The Commission has issued the enclosed Amendments No. 26 to Facility Operating Licenses Nos. DPR-32 and DPR-37 for the Surry Power Station Units Nos. 1 and 2. The amendments consist of an added condition to the license for Surry Unit No. 2 and changes to the Technical Specifications in partial response to your application dated September 27, 1976, as supplemented October 29, 1976, and your submittals dated October 19, 1976, and November 15, 1976. We did not include any revisions in your Technical Specifications related to the Nuclear Enthalpy Rise Hot Channel Factor (F_{NH}); hence, you should continue to operate Surry Unit No. 2 under the existing Technical Specifications for F_{NH} and the additional restrictions of your August 18, 1976 letter (Serial No. 194).

Amendment No. 26
License No. DPR-32

ATTACHMENT TO LICENSE AMENDMENT NO. 26

Amendment No. 26
License No. DPR-37

HOT CHANNEL FACTOR NORMALIZED
OPERATING ENVELOPE

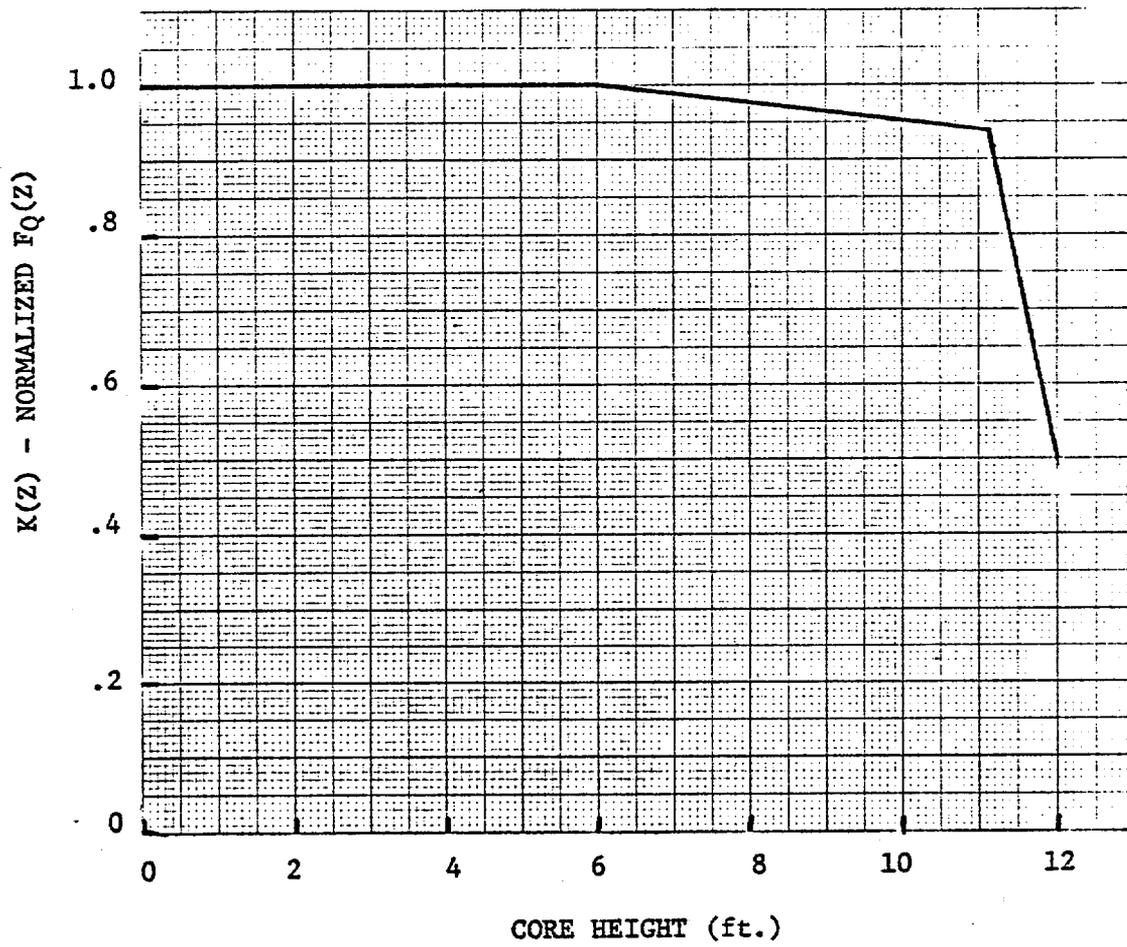
where P is the fraction of rated power at which the core is operating, K(Z) is the function given in Figure 3.12-8, Z is the core height location of F_Q .

The results of the loss of coolant accident analyses are conservative with respect to the ECCS acceptance criteria as specified in 10 CFR 50.46 using an upper bound envelope of 2.00 times the hot channel factor normalized operating envelope of TS Figure 3.12-8.

$$F_Q(Z) \leq (2.00/P) \times K(Z) \text{ for } P > .5$$

$$F_Q(Z) \leq (4.00) \times K(Z) \text{ for } P \leq .5$$

$$F_{\Delta H}^N \leq 1.55 (1 + 0.2(1 - P))$$

HOT CHANNEL FACTOR NORMALIZED
OPERATING ENVELOPE

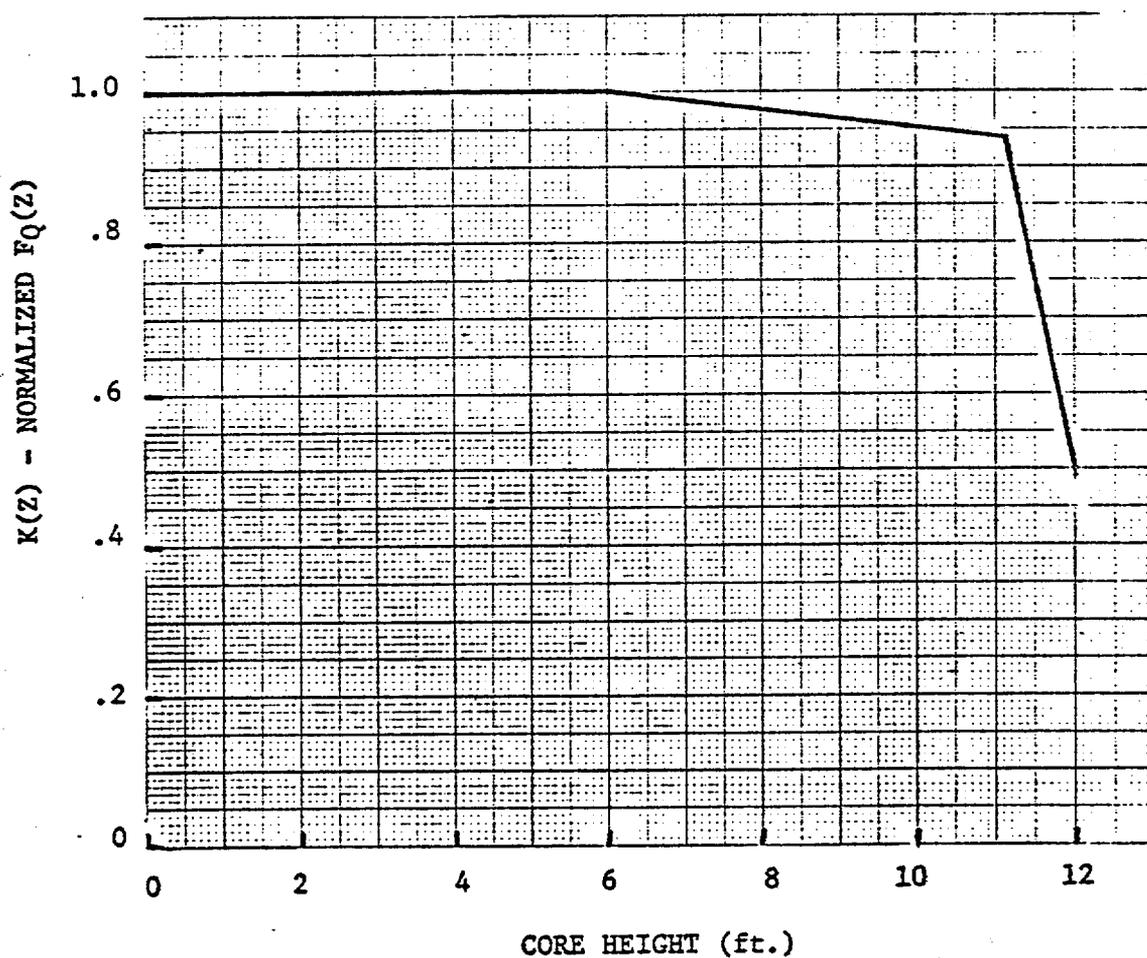
where P is the fraction of rated power at which the core is operating, K(Z) is the function given in Figure 3.12-8, Z is the core height location of F_Q,

The results of the loss of coolant accident analyses are conservative with respect to the ECCS acceptance criteria as specified in 10 CFR 50.46 using an upper bound envelope of 2.00 times the hot channel factor normalized operating envelope of TS Figure 3.12-8.

$$F_Q(Z) \leq (2.00/P) \times K(Z) \text{ for } P > .5$$

$$F_Q(Z) \leq (4.00) \times K(Z) \text{ for } P \leq .5$$

$$F_{\Delta H}^N \leq 1.55 (1 + 0.2(1 - P))$$
